UNITED STATES PATENT AND TRADEMARK OFFICE

Office Action Summary

10/604,112

DETAILED ACTION

Fig.2

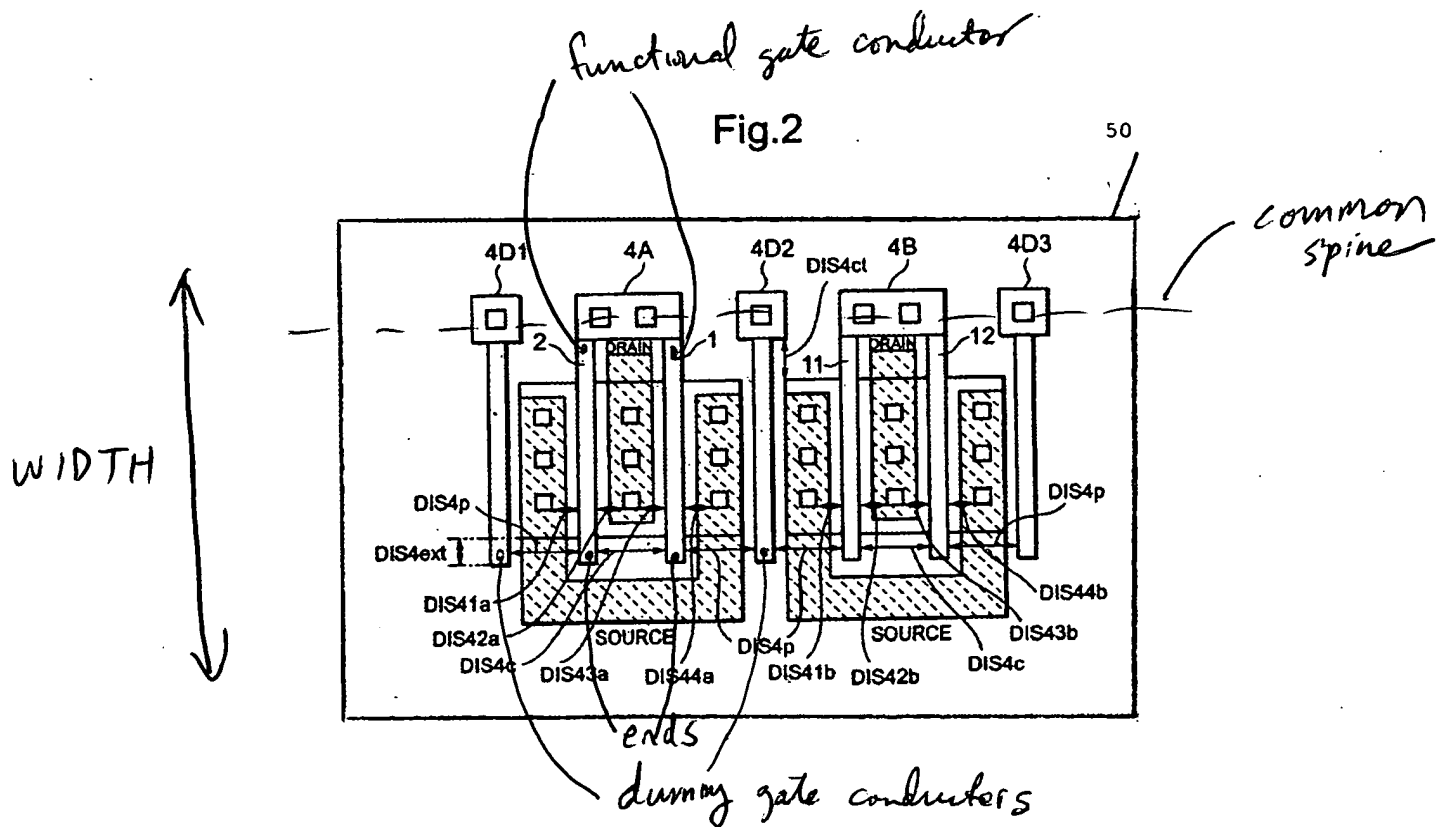
5. Insofar as definite, claims 1, 4 thru 12, and 15 thru 22 are rejected under 35 U.S.C. 103(a) as being unpatentable over Iwasaki 6,833,595 B1 in view of Uehara et al. 5,946,563. Iwasaki discloses (see, for example, Fig. 2) a semiconductor device (electronic device) comprising a semiconductor substrate, transistor 4A, gates (functional gate conductors) 1, 2, common spine, dummy gates (dummy gate conductors) 4D1, 4D2, and element isolation region (insulating layer) 50. The gates extend in a widthwise direction from a common spine, the common spine

extending in a direction perpendicular to said widthwise direction. The gates are positioned substantially parallel to each other in said widthwise direction and periodically spaced apart a fixed distance in said direction substantially perpendicular to said widthwise direction. The dummy gates are positioned substantially parallel to each other in a widthwise direction and periodically spaced apart a fixed distance in a direction substantially perpendicular to said widthwise direction. The dummy gates are not positioned between gates 1, 2 and adjacent to ends of said gates.

Regarding claims 4, and 15, see, for example, Fig. 2 wherein Iwasaki discloses the dummy gates 4D1, 4D2, and gates 1,2 having the same gate widths.

Regarding claims 5, 6, 16, and 17, see, for example, Fig. 2 wherein Iwasaki discloses dummy gate (additional dummy gate conductors) 4D3.

Regarding claims 9, 10, 20, and 21, see, for example, Fig. 2 wherein Iwasaki discloses source/drains SOURCE /DRAIN.
